MANDATORY SERVICE BULLETIN

NO. MSB 42-063/1

Inspection and Modifications of the NLG centering unit mount.

“Modification of NLG centering unit mount”

1	Mounting block	P/N: D60-3223-64-51_1
---	----------------	-----------------------

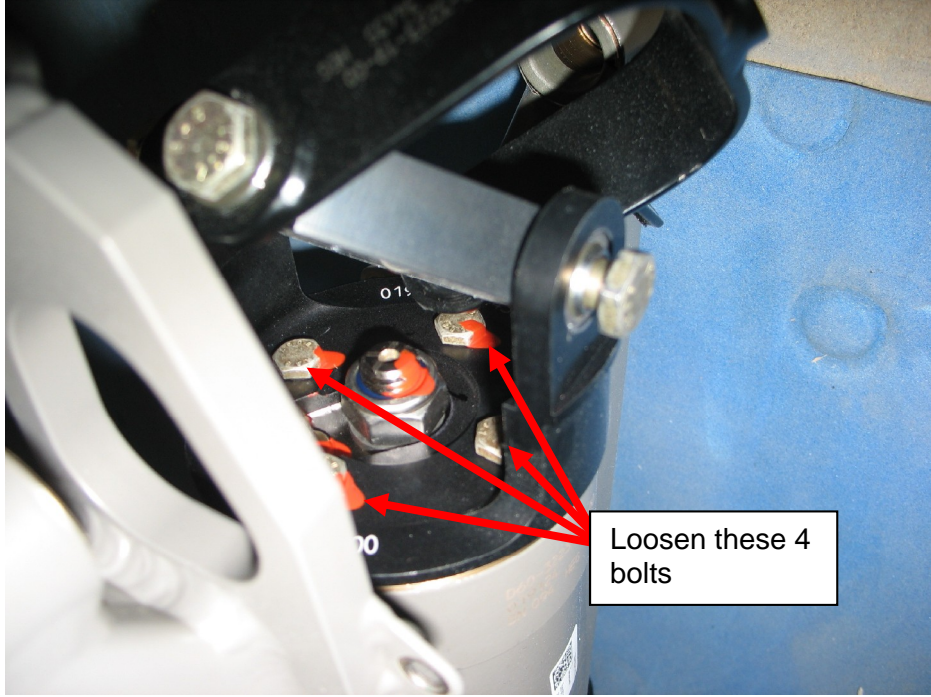
<p>8.</p>	<p>Inspect the mounting block P/N: D60-3223-64-51 for cracks.</p> <p>Criterion 1 If there are cracks one both sides, replace the damaged mounting block with a new one (D60-3223-64-51_1) immediately.</p> <p>Criterion 2 If there are cracks similar to the ones in the picture below on one side only, replace the damaged mounting block with a new one (D60-3223-64-51_1) within the next 100 flight hours from the inspection. If this criterion is met proceed with step 10.</p> 
<p>9.</p>	<p>Remove the ring P/N D60-3223-64-31 from the cracked mounting block and push the bearing P/N LBBR 12-2LS clean of Mounting Block with a 16mm (0.63in) pin. Install the bearing in the new mounting block, use Aeroshell 5 or equivalent and tighten the ring.</p>
<p>10.</p>	<p>Make sure the tire is aligned straight. Align the centring unit. Install the centering unit back onto the NLG leg by securing it with the four bolts (20Nm /15 ft lb). Apply Loctite 243 or equivalent onto the threads.</p>

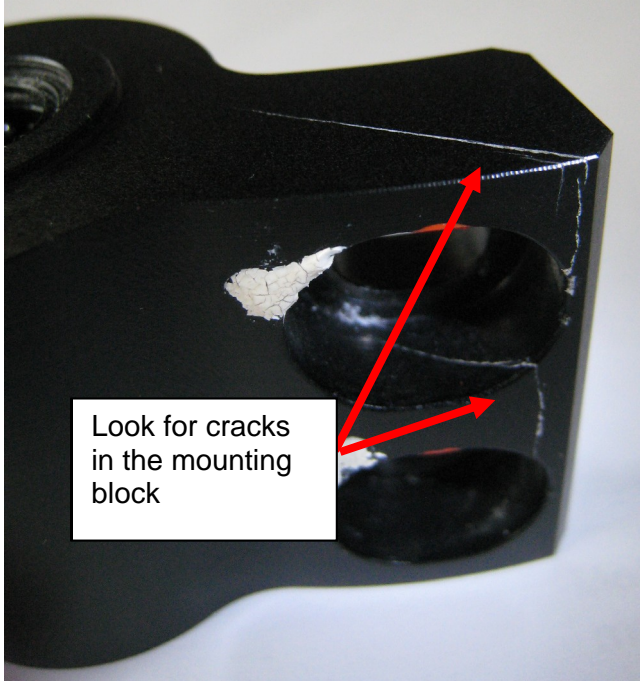
Modification of the centering unit mount:
Mark 3 mm (0.12 in) left and right from the inner edges of the mount.
File the edges to a radius of 3 mm (0.12 in).

CAUTION: Make sure not to damage the NLG surface while filing the edges.
